# **MONITORING YEAR 1 ANNUAL REPORT**

## **CANDY CREEK MITIGATION SITE**

RE: Draft Monitoring Year 1 Report Comments  
Candy Creek Mitigation Site (DMS #96315)  
DMS Contract Number 5794  
RFP Number 16-005568  
Guilford County, NC

We have reviewed the comments on the Monitoring Year 1 Report for the above referenced project dated January 9, 2018 and have revised the report based on these comments. The revised digital files are submitted with this letter. Below are responses to each of your comments. For your convenience, the comments are reprinted with our response in italics.

Figure 3.3 Integrated Current Condition Plan View  
Candy Creek Mitigation Site  
DMS Project No. 96315  
Monitoring Year 1 - 2017  
Guilford County, NC

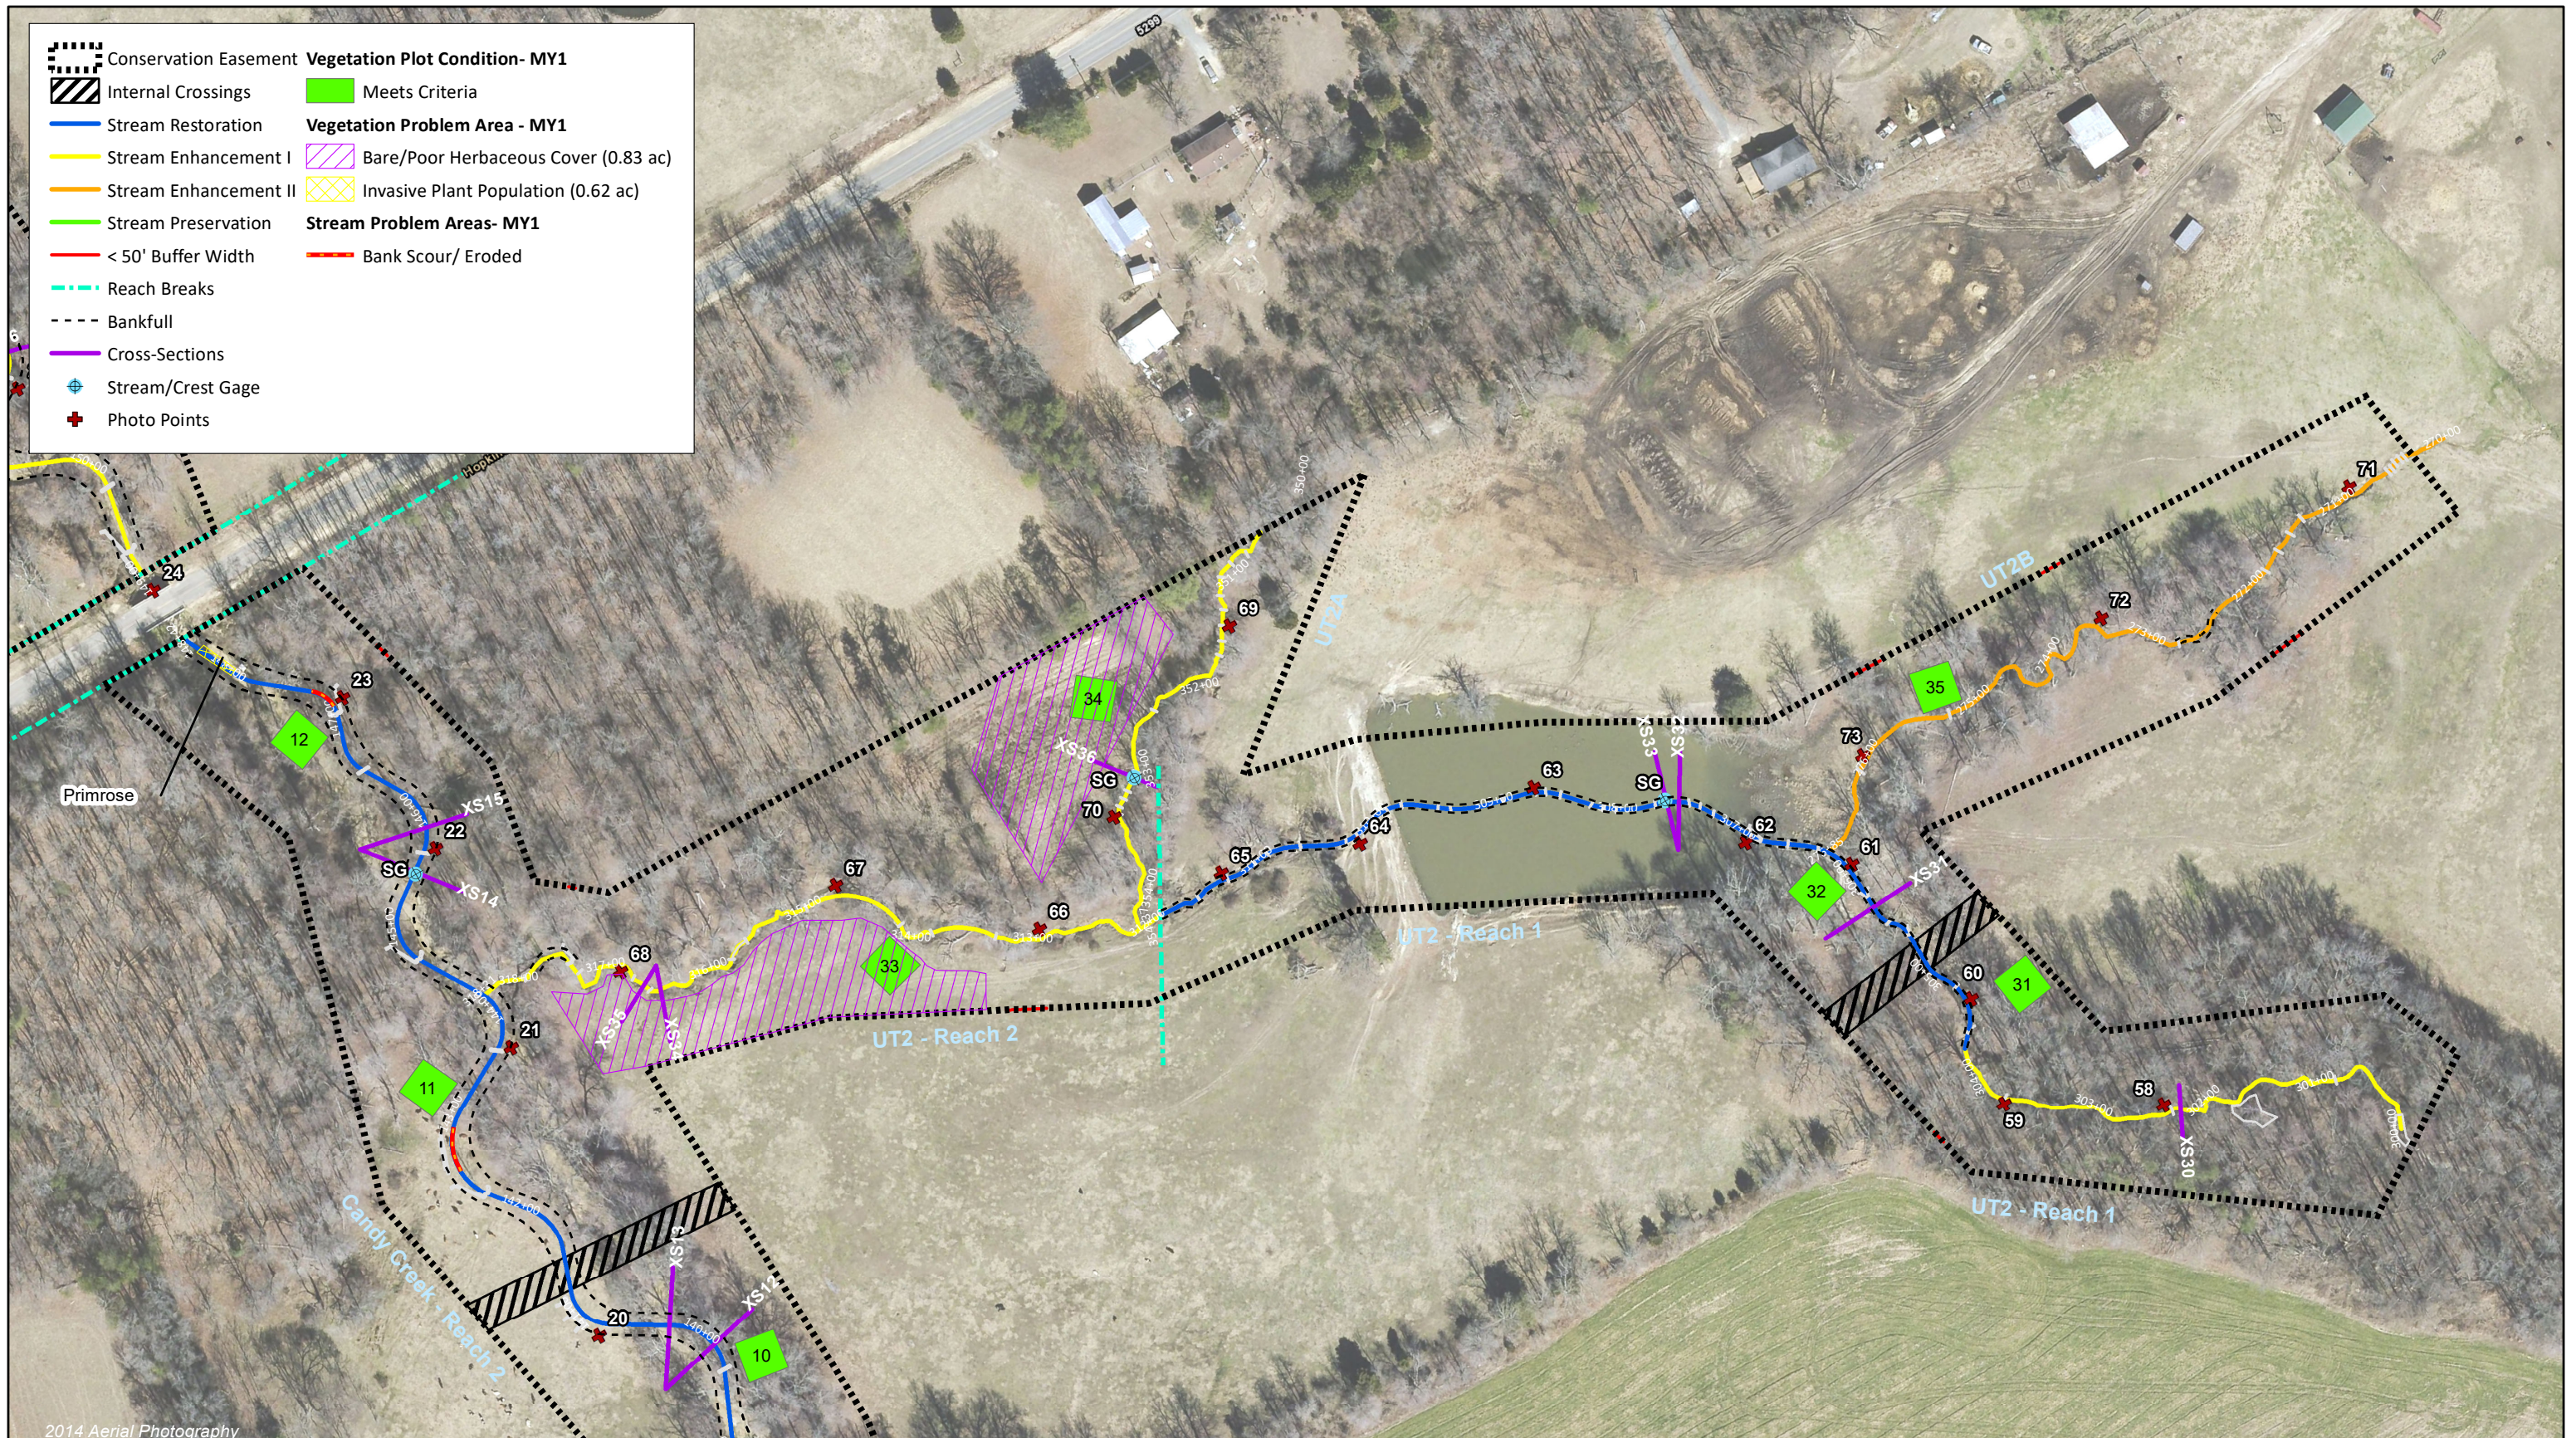
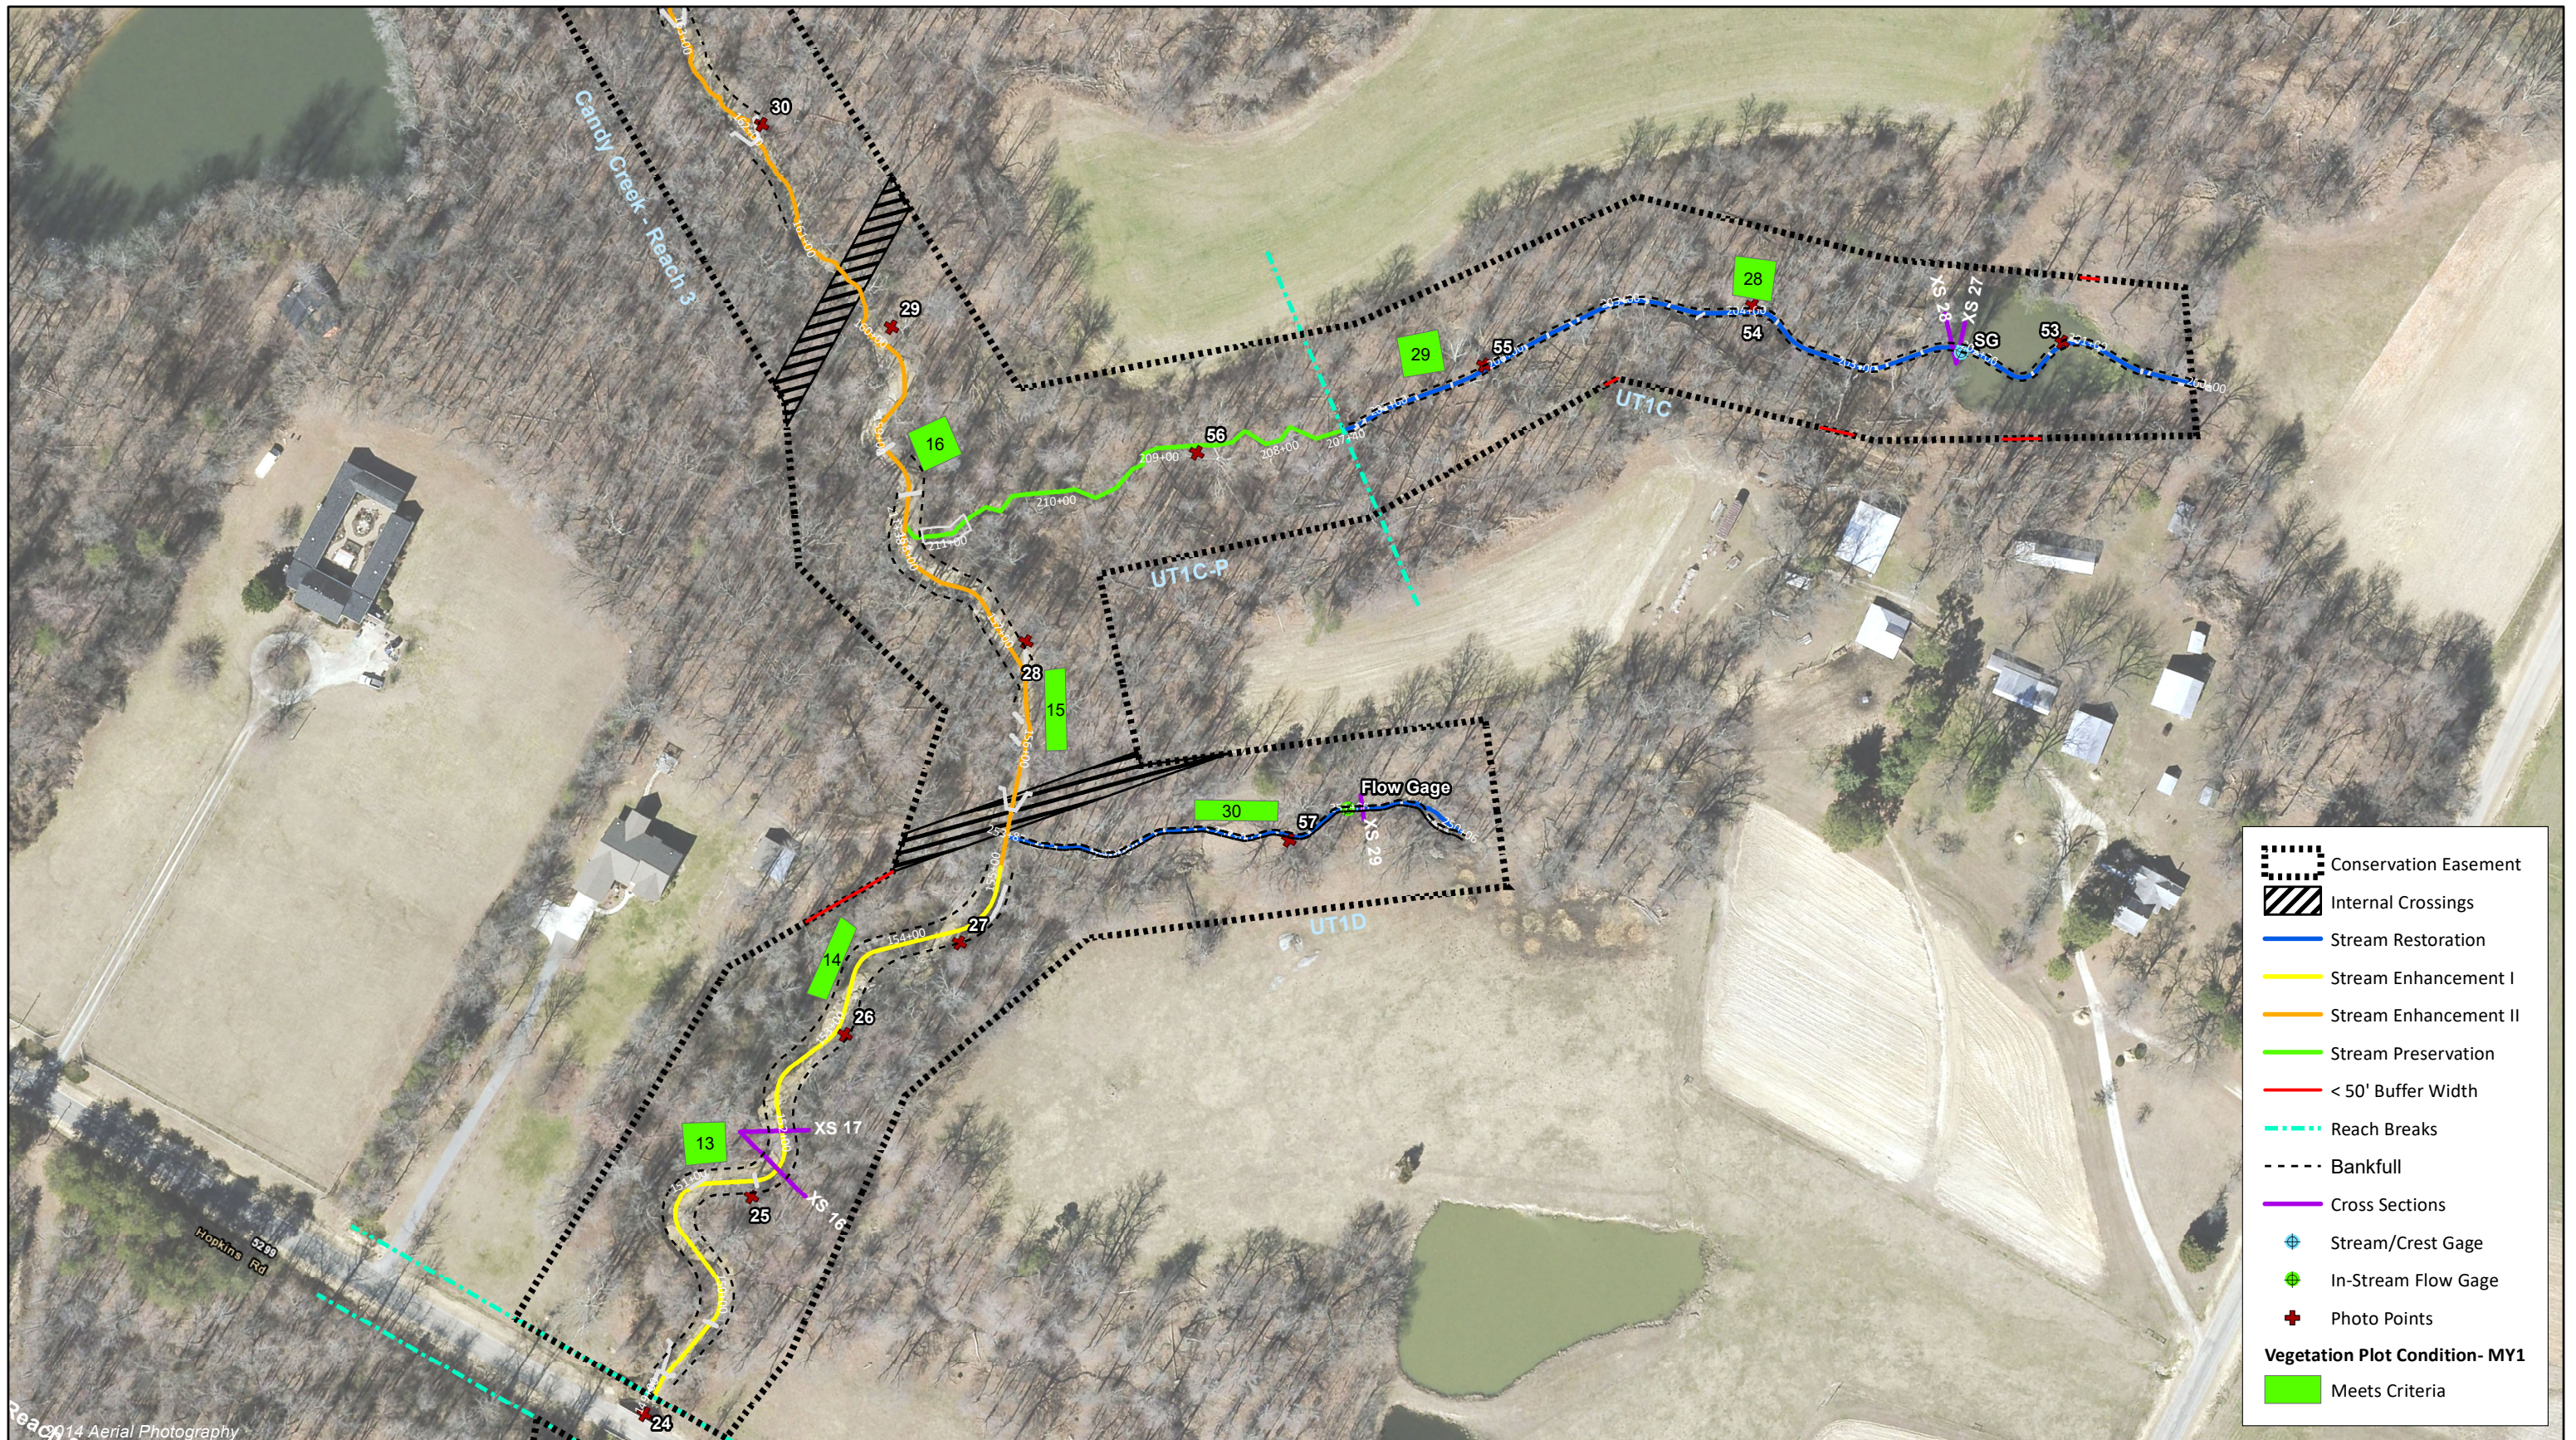
3. The CCPV shows sections along Candy Creek Reach 1, UT4, UT5, Candy Creek Reach 2, UT2 Reach 1, Candy Creek Reach 3, UT1C and Candy Creek Reach 4 where the buffer width is less than 50 feet. Wildlands addressed this in the As-Built Baseline report and indicated that the total length of these sections is approximately 3.1% of the total project length. Please address this in a sentence or two in the MY1 report and include that this is less than the 5% allowed by the IRT.

*An explanation was added to the end of the executive summary, page ii and section 1.2, page 1-2.*
